STATE OF OHIO
DEPARTMENT OF TRANSPORTATION
HUR-CR 11-2.96
BASELINE ROAD/BROADWAY ST.
VILLAGE OF PLYMOUTH
HURON COUNTY
RICHLAND COUNTY

REPLACEMENT OF A DETERIORATED WOOD BEAM BRIDGE OVER ASHLAND RAILWAY IN VILLAGE OF PLYMOUTH ON EXISTING HORIZONTAL ALIGNMENT AND MODIFIED VERTICAL ALIGNMENT WITH APPROACH ROADWAY WORK.

ADDENDUM 1

TRAFFIC CONTROL
 STA. 153+00.00 TO STA. 158+00.00

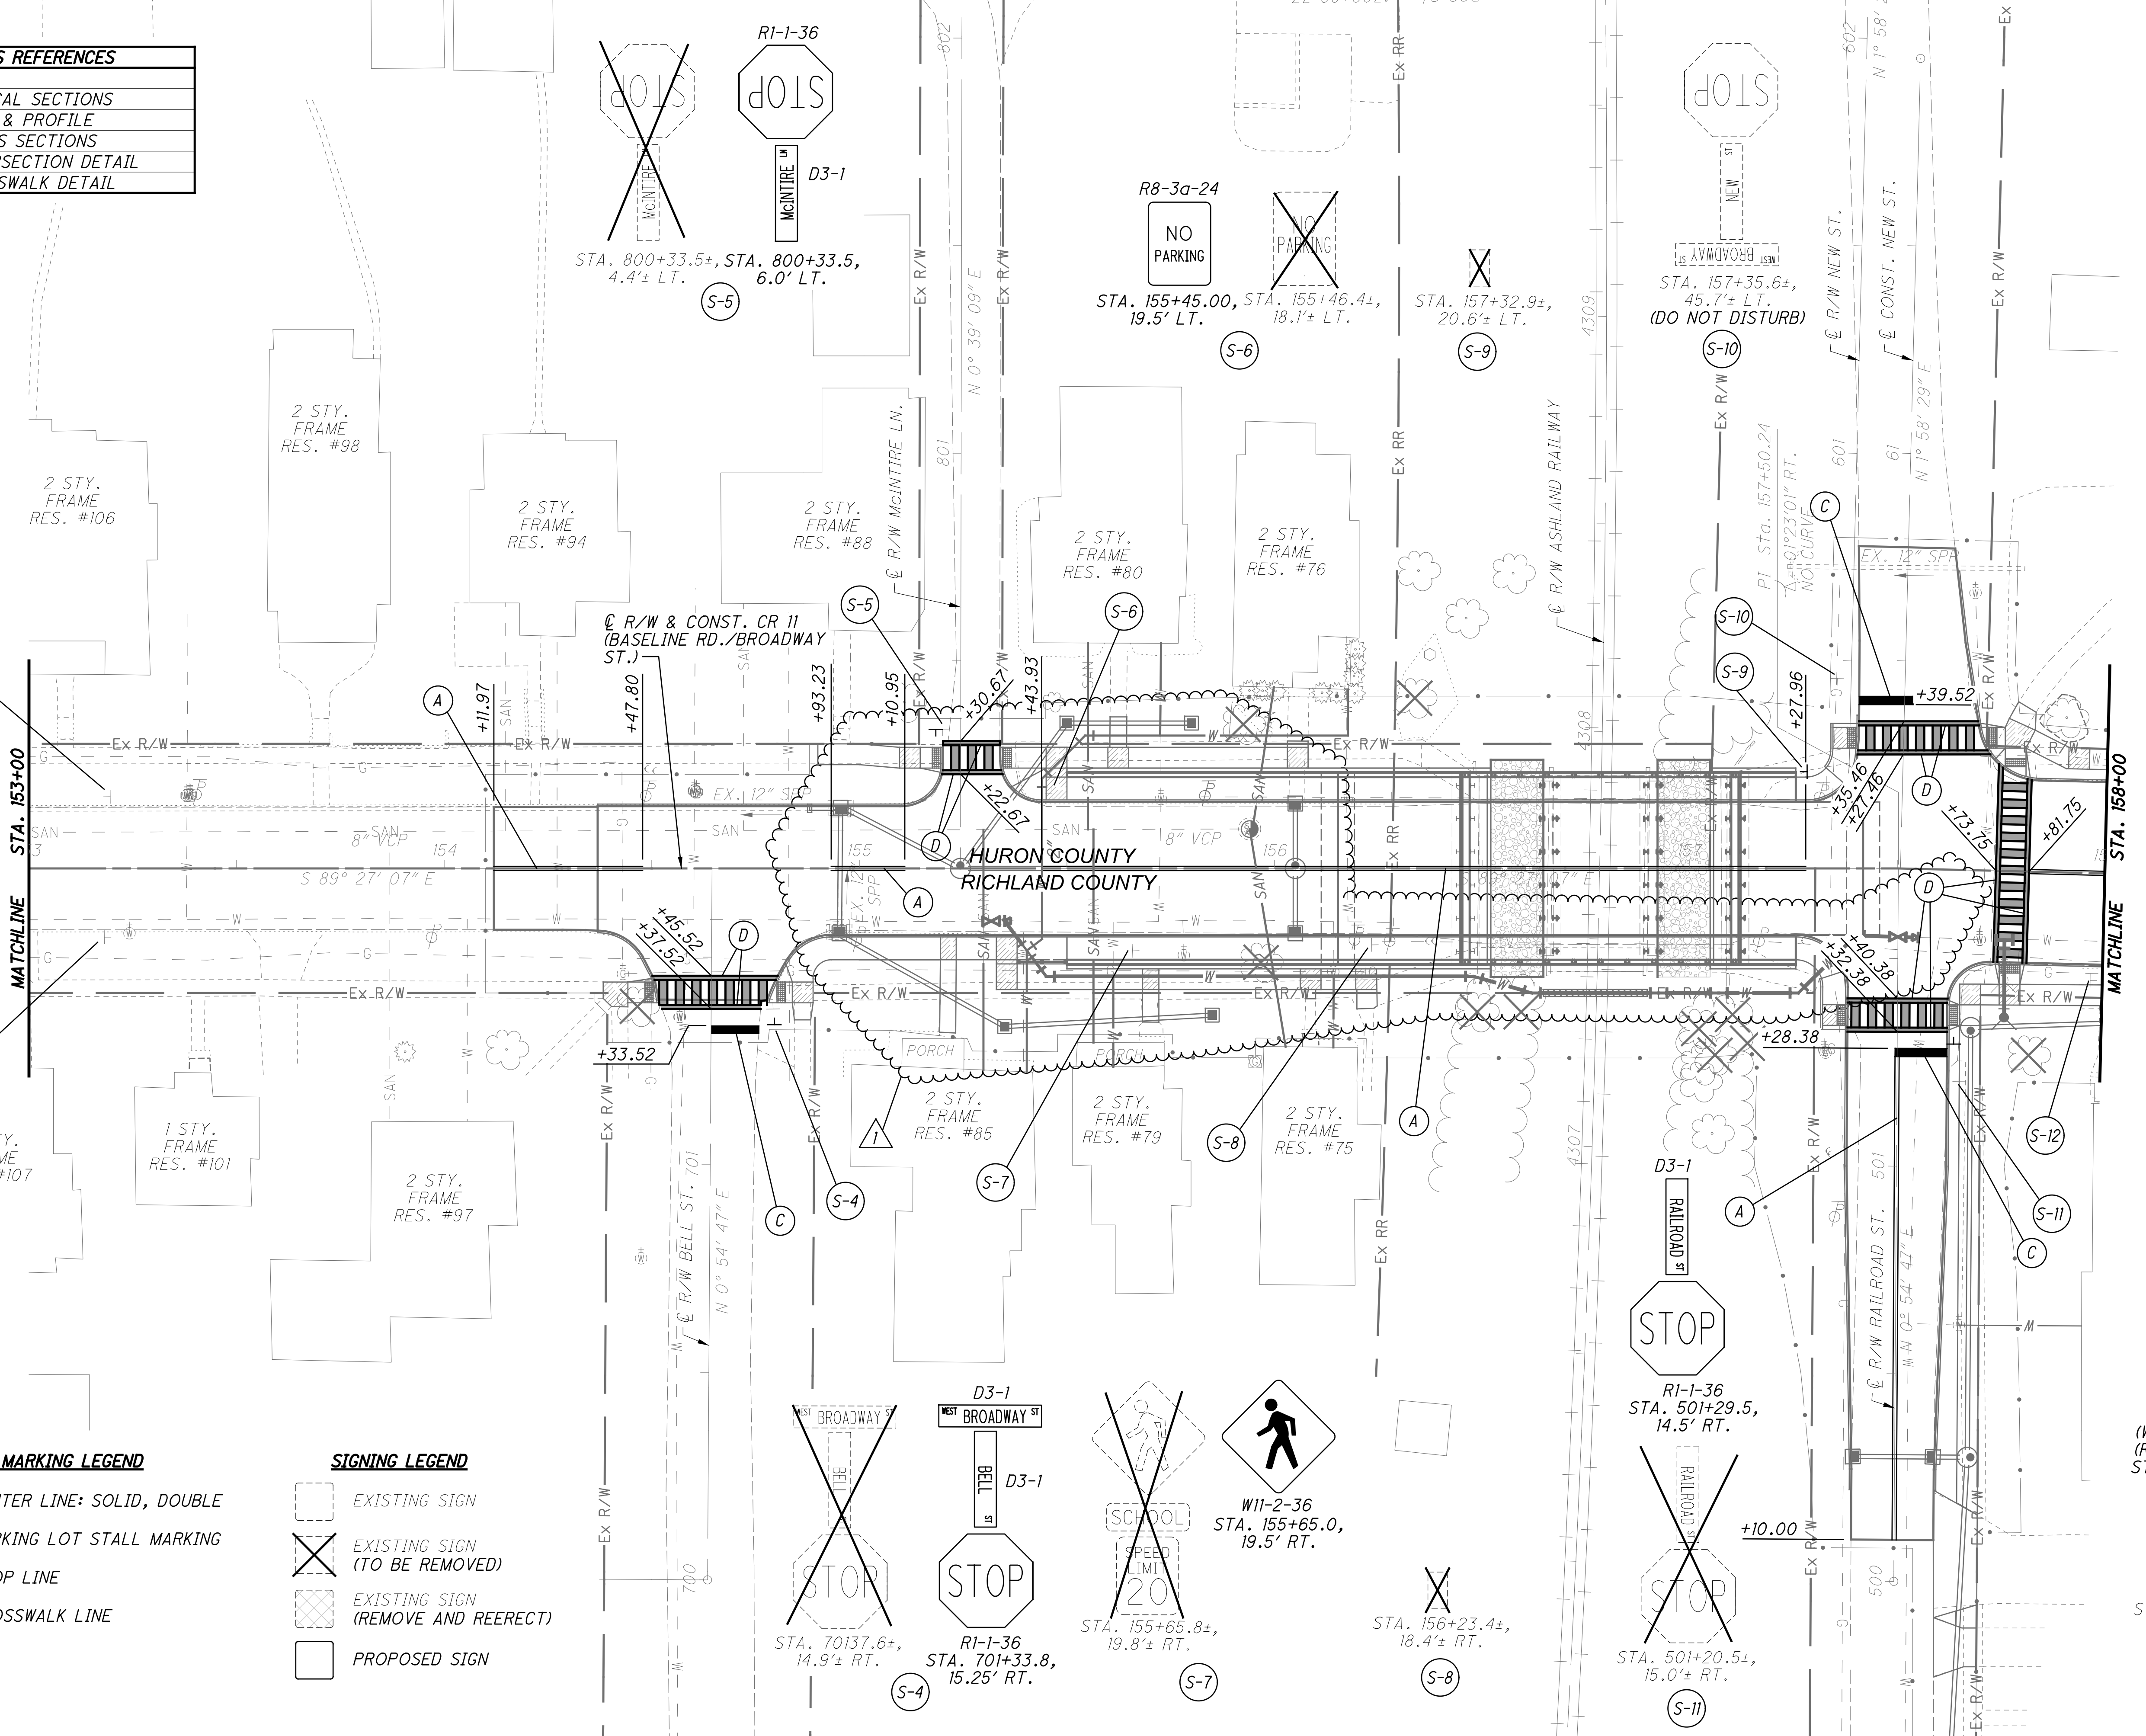
ADDENDUM 1
 4/14/26 REVISED DRAINAGE AND WATERLINE

MSE WALL 1 - PLAN AND ELEVATION
 HU-CR-11-2.96
 BASELINE RD./BROADWAY ST. OVER ASHLAND RAILWAY

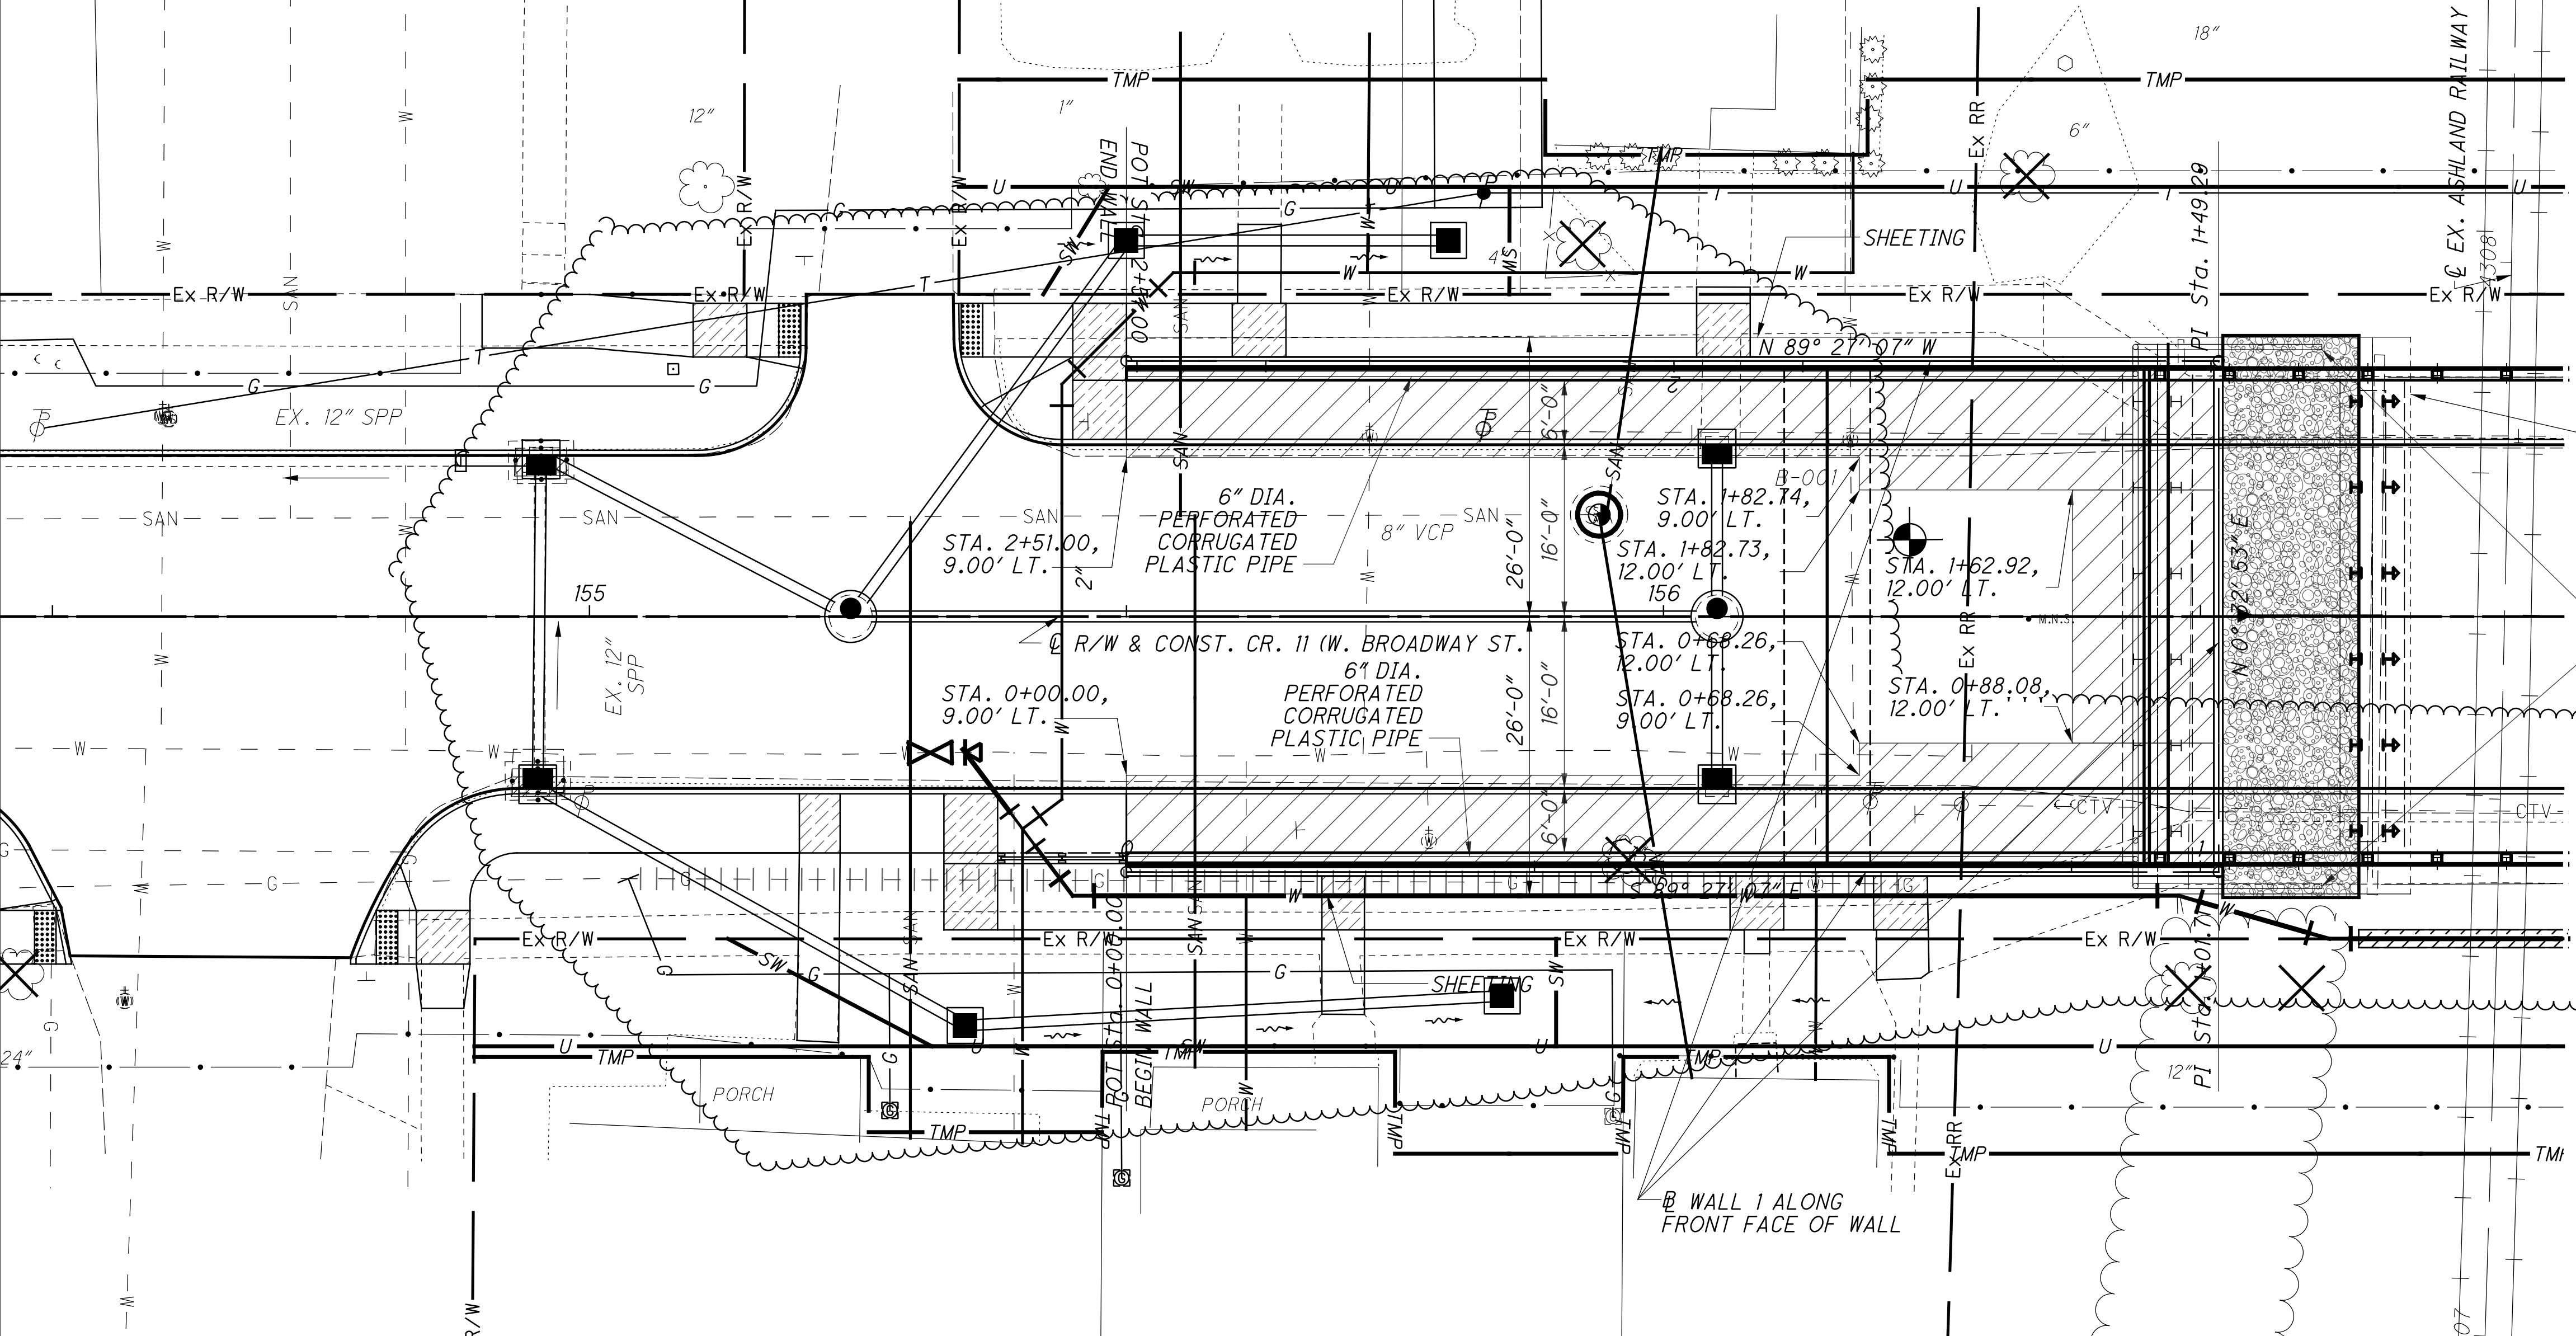
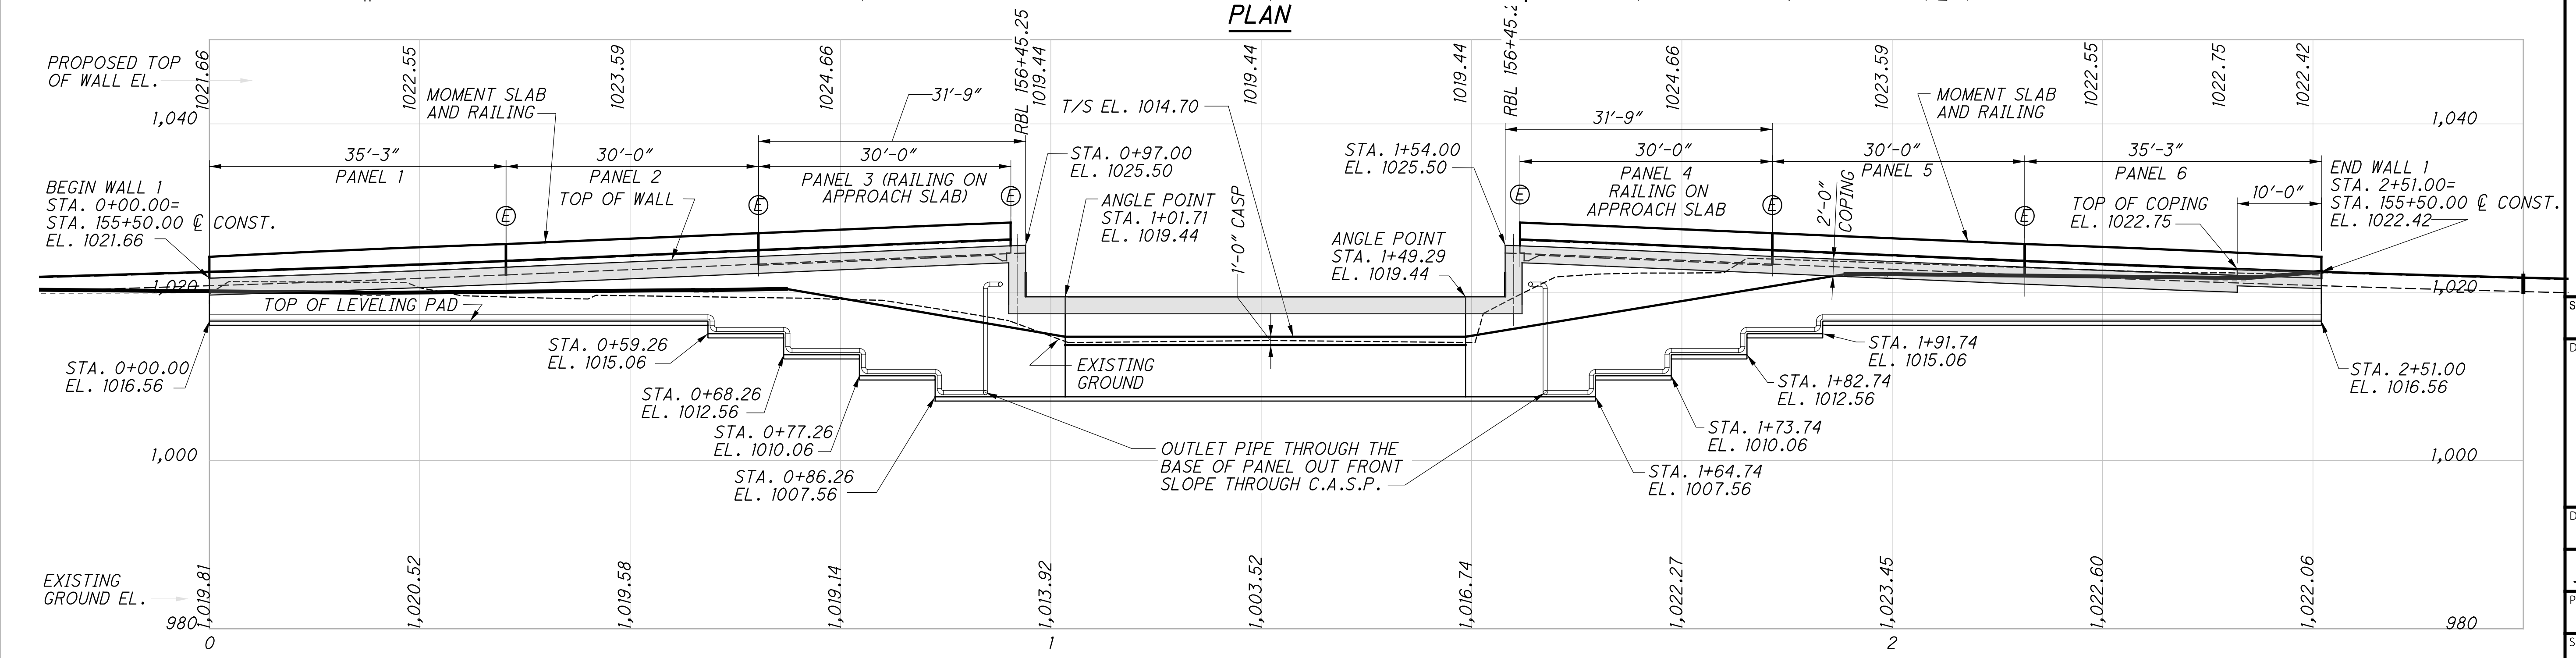
| ADDENDUM 1 | | |
|------------|---------|--------------------------------|
| 1 | 4/13/26 | REVISED DRAINAGE AND WATERLINE |
